TECHNICAL SERVICE BULLETIN

Subject: TSB for Scrubmaster B400RH-Checking/Replacing washers on A04 Drive Controller

Improvement

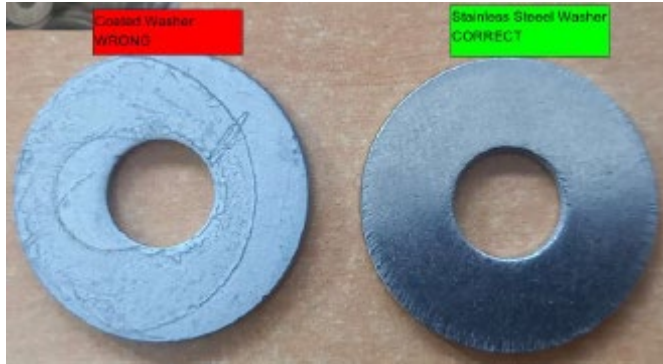
Reason for Change

Please travel immediately to the machines on the list and check whether the correct washers have been installed on the drive control fuse. Incorrect washers can cause short-term damage to the drive controller.

Up to 4pcs washers ISO 7093-8-200HV-A4-70 with the **spare part number #730526** must be replaced. The screws must be tightened with **9.5 Nm**.
